Hume Coal and Berrima Rail Project

Response to the Independent Planning Commission Assessment Report dated 27 May 2019

Prepared for Hume Coal Pty Ltd
April 2020

Make good flow chart

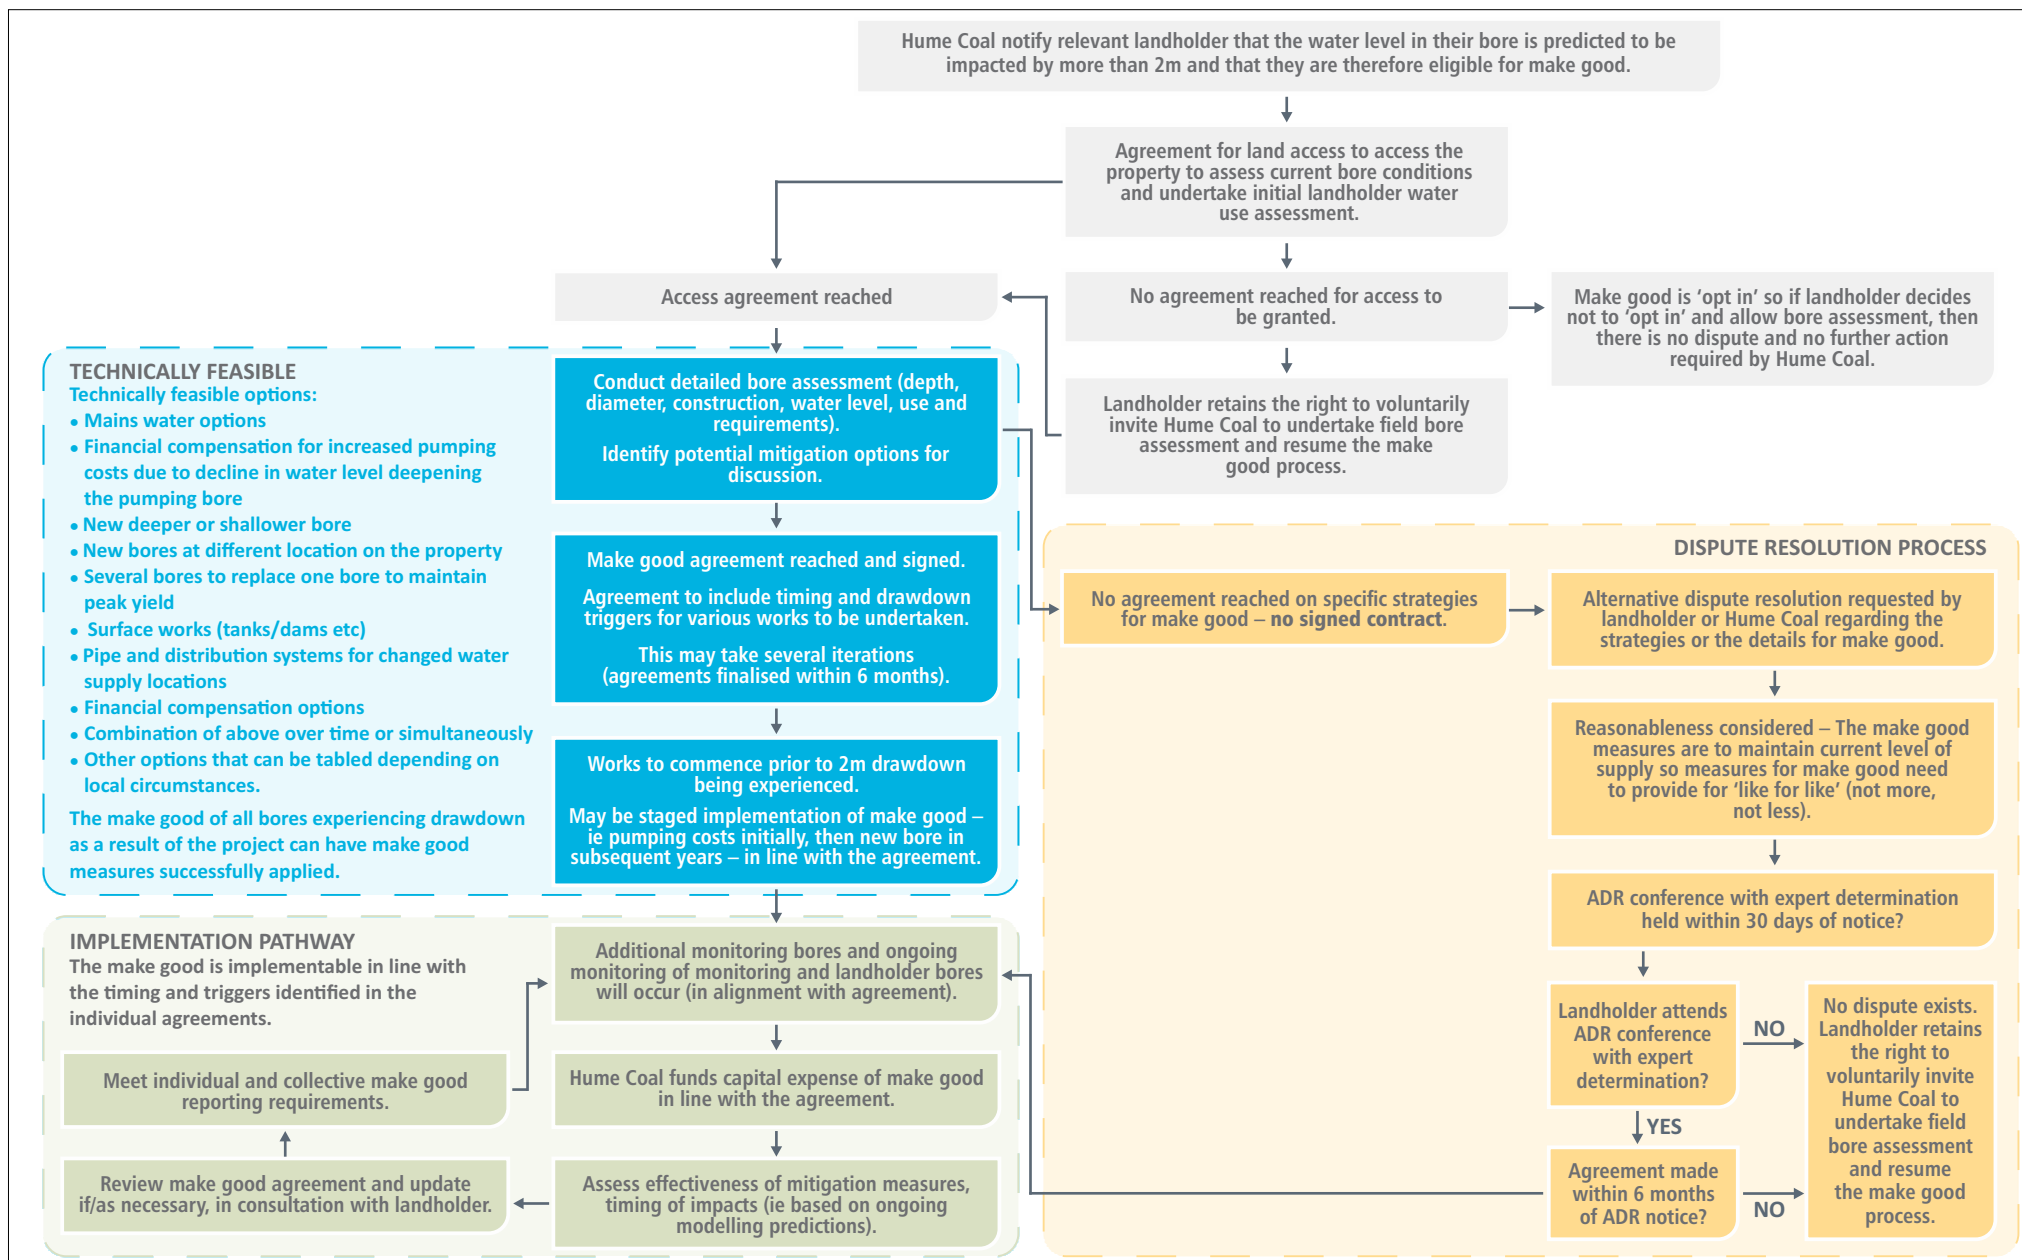
R6	That the Department give close attention to the practical adequacy of make good provisions during the final assessment process, with an independent review if necessary. This should include the practical aspects such as dispute resolution and economics as well as the technical.	This recommendation is addressed in Section 5.5.3 of this report and discussed further in Appendix B.
R7	The Applicant is to confirm whether the provisional Water Treatment Plant does form part of the Project – and if so, provide suitable information to permit an appropriate assessment of its impacts.	The WTP no longer forms part of the Project. A response to this recommendation is provided in Section 6 of this report.
R8	Should underground emplacement and water impounded have to cease for any reason, the Applicant is to confirm how long under normal mining operations it would take for the reject emplacement stockpile and Primary Water Dam to reach capacity.	The surface water aspects of this recommendation are addressed in Section 6.5.1 and discussed further in Appendix B.

The loosely defined pathway for proponents to manage conflict resolution of 'make good' in NSW means that projects such as Hume Coal have the potential for uncertainty and disruption. However, Hume Coal have been aware of this throughout the planning of the process and have designed a detailed strategy for resolving conflict at every stage.

Hume Coal have mapped out the potential areas of conflict in this process and have a solid approach to dispute resolution (see Figure 5.3).

Hume Coal and Berrima Rail Project
IPC response report
Figure 5.5

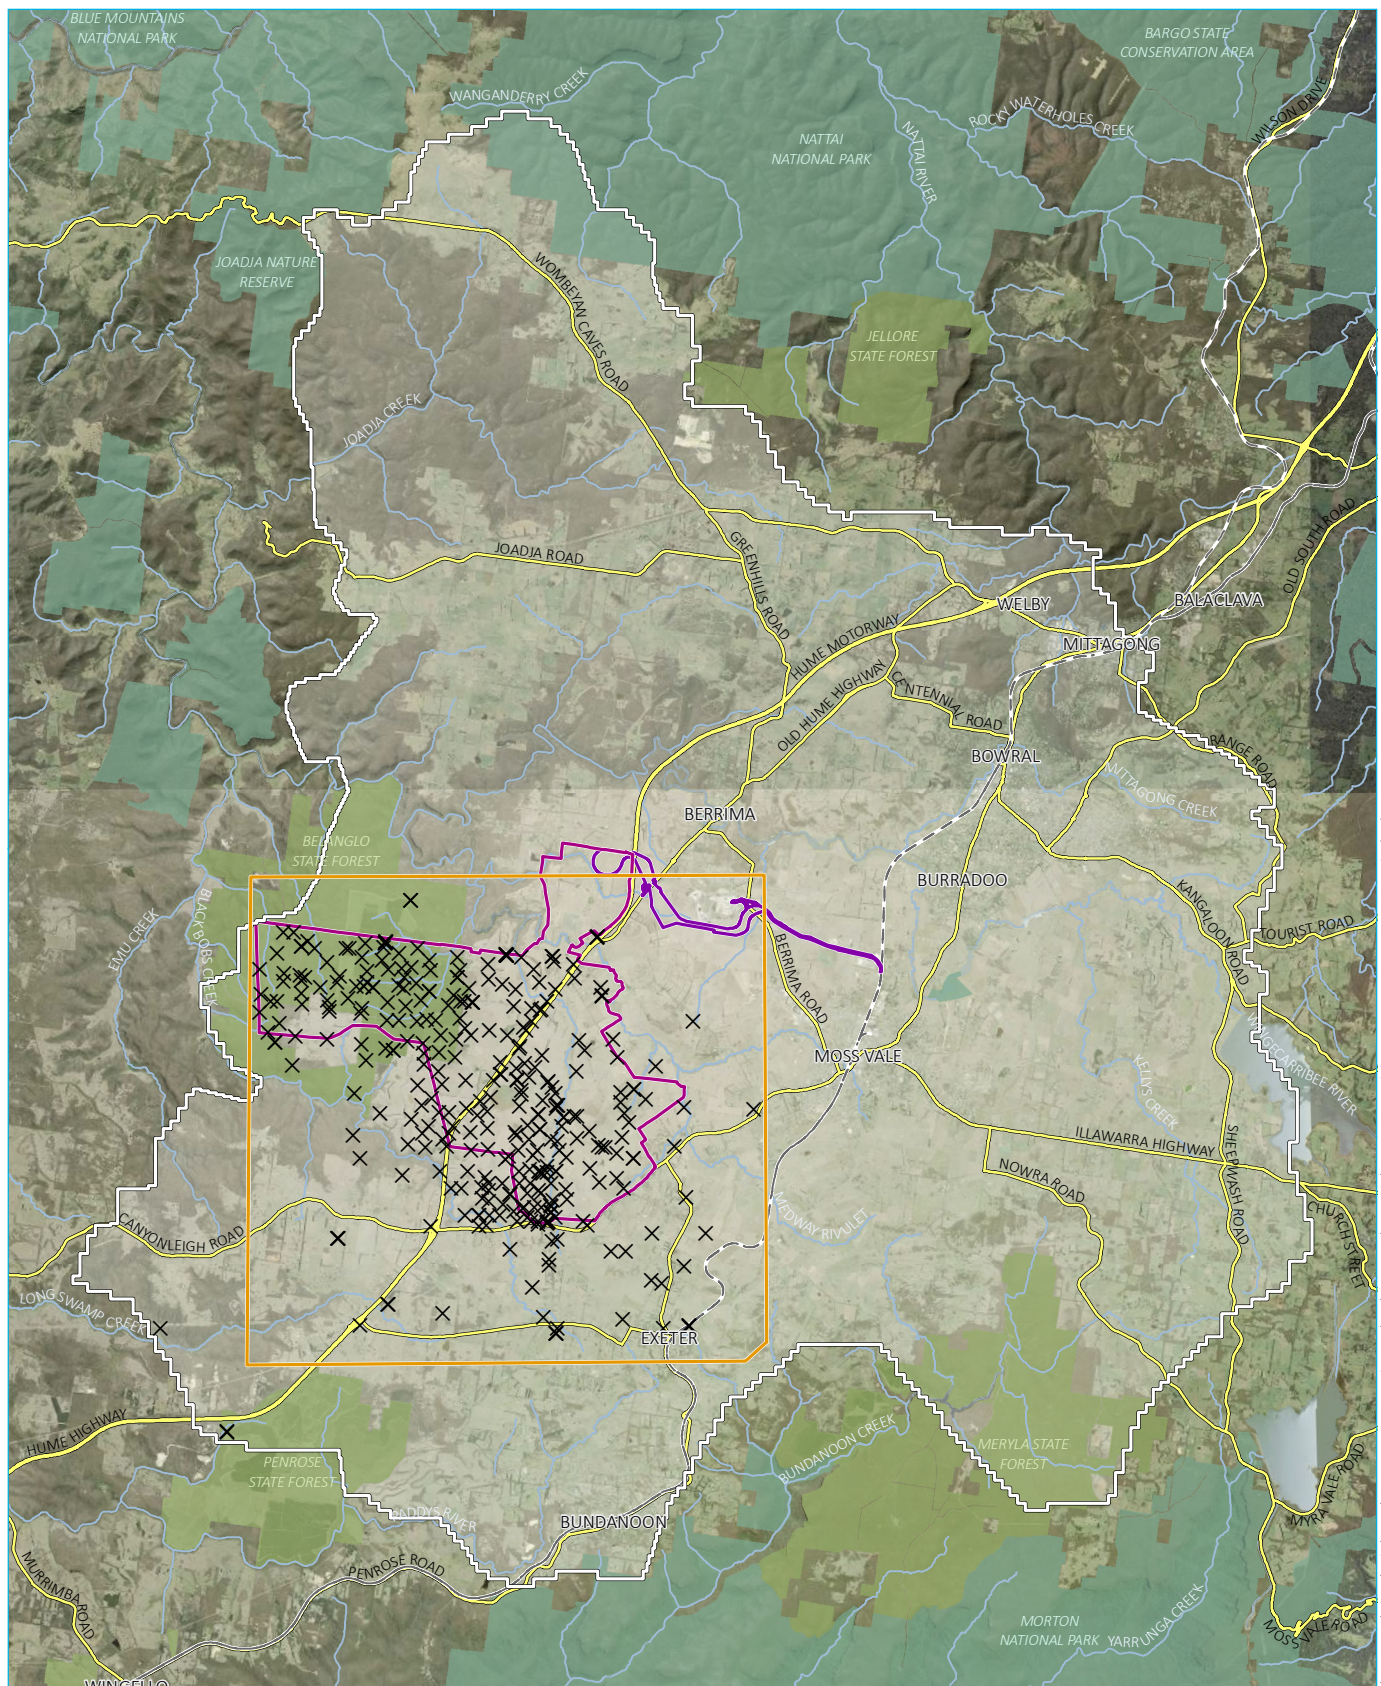
Reference number	IPC recommendations	Summary response
R5	<p>Because the Applicant and Department of Industry - Water remain a considerable distance apart regarding their positions on the groundwater modelling, the Commission suggests that the Department or the Applicant, or both of them jointly (and in any case in consultation with Department of Industry - Water), engage a new independent expert (or alternatively a small technical group with Chair) with experience in groundwater modelling with a view to resolving ongoing differences of opinion. The independent expert/Chair should consider:</p> <ul style="list-style-type: none"> • what practical steps, if any, can be taken to make the model a class 2 model or seek agreement on the class of the model; • what additional work is required to establish the extent to which the emplacement of water in mined-out voids will reduce the level of drawdown in the later years of the project; • the range used for the input parameters in the modelling sensitivity/uncertainty analysis and recommend if a wider range is required so that there is no unreasonable truncation of results; and • if additional geological information is required. 	<p>Hume Coal engaged Dr Lloyd Townley of GW-SW Pty Ltd to conduct an independent review of the groundwater modelling.</p> <p>Townley (2020) concluded that modelling undertaken for the Hume Coal Project is fit for purpose, for the purpose of predicting groundwater inflows to the proposed mine and drawdown of the water table within and near the Project area. This conclusion is consistent with the previous expert reviews by HydroAlgorithmics Pty Ltd (2016), Kalf and Associates Pty Ltd (2016) and HydroGeoLogic (2017, 2018) on behalf of DPE that concluded the original EIS model and subsequently the Modified EIS Model (RTS model) were fit for purpose. Townley (2020) concludes that the model is a Class 2 model, and has some elements of a Class 3 model.</p>

At the meeting with Dol Water on 30 July 2019, and following a presentation on the geology of the Hume Coal Project, Mr Druzynski of Dol Water stated he “wasn’t aware Hume Coal had so much geological data”.

The geological and hydrogeological data for the Project is extensive, with 345 individual holes drilled within the A349 (179 of which are within the proposed mining area, see Figure 5.5). All Hume Coal drill holes have been geophysically logged, core photographed and used to develop a robust geological model. In addition to the drilling of boreholes, extensive aerial magnetic and radiometric surveys have been conducted over the Project area. Surface magnetic surveys were also undertaken targeting specific geological structures that were located by the aerial surveys. Surface seismic surveys were undertaken in the Belanglo State Forest and property owned by the applicant. In total, approximately 36 linear km of data was obtained. Geological mapping was undertaken on accessible properties and where drilling was undertaken.

Figure 5.5 shows the extent of the Hume Coal geological model, mineral drill hole data locations and the extent of the groundwater model. Cross sections have been cut within the geological model and groundwater model for comparison purposes, as requested by DPIE Water at a meeting held in July 2019. These cross sections are discussed further in Annexure A of Appendix B.
